Philips Domestic Appliances and Personal Care

Service Manual

FC9103 /A /B /C

To recognize the switches:

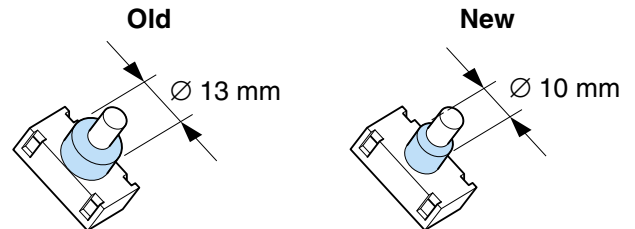
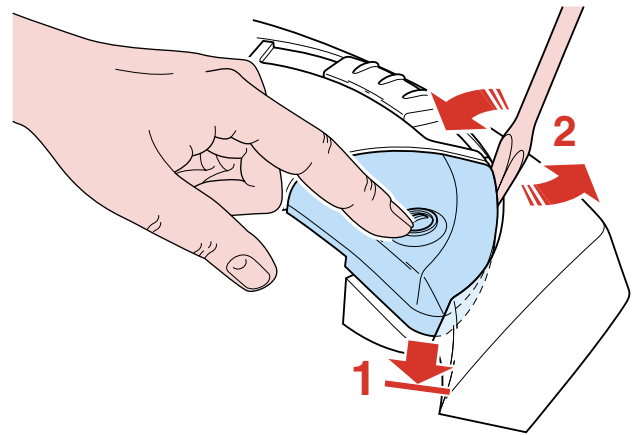
- Due to introduction of a **new switch** (item 11) 0320 onwards, which is not interchangeable with the old switch soldered on the PCB (item 12).
- The switch lever assy (item 11a) is also modified.

New spares are:

11	Switch soldered version	- 4322 006 50600
11a	Switch lever assy	- 4322 009 08980
parts of 15	Switch and Cord winder knob	- 4322 009 09000
